NORTH AMERICAN AVIATION, INC • MUNICIPAL AIRPORT • LOS ANGELES 45, CALIF

NO. 23
April 11, 1947

CARBURETOR VAPOR RETURN LINE HOSE REPLACEMENT

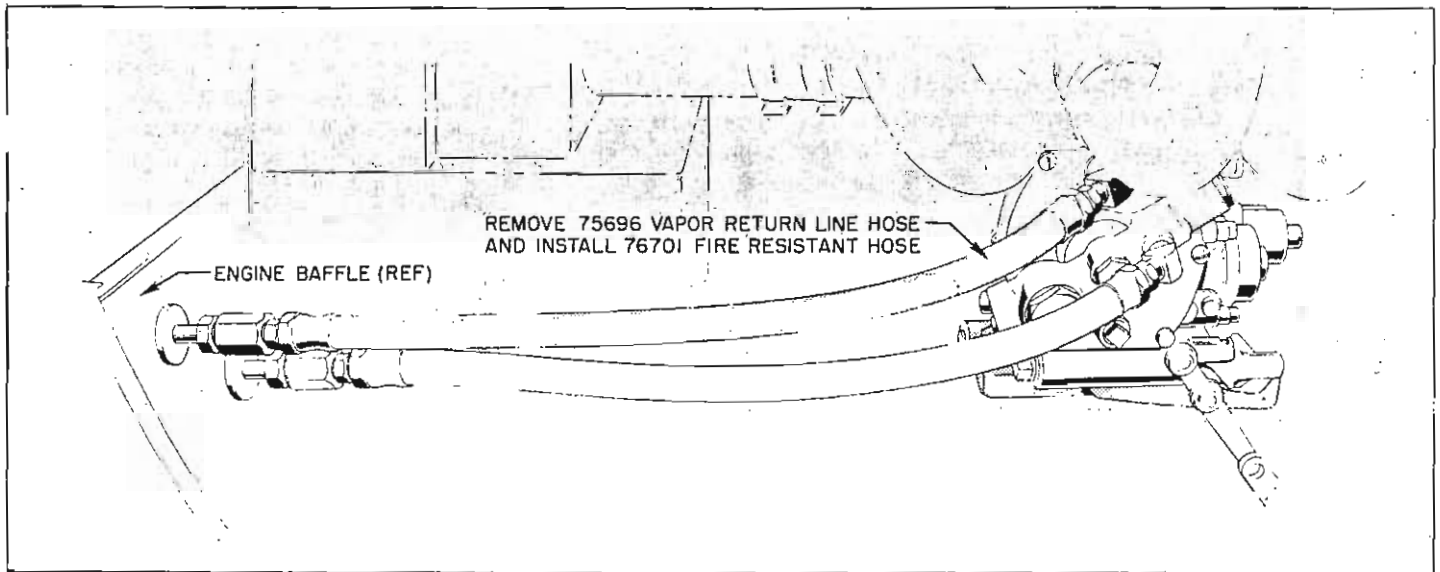
Airplanes NAV-4-851 and subsequent will have the metal vapor return line routed through the firewall in such a manner that a fire resistant hose is not required. Fire resistant hose is identified by a broken red and a broken white stripe running lengthwise of the hose.

Install 76701 fire resistant hose furnished in 145-89027 kit as shown:
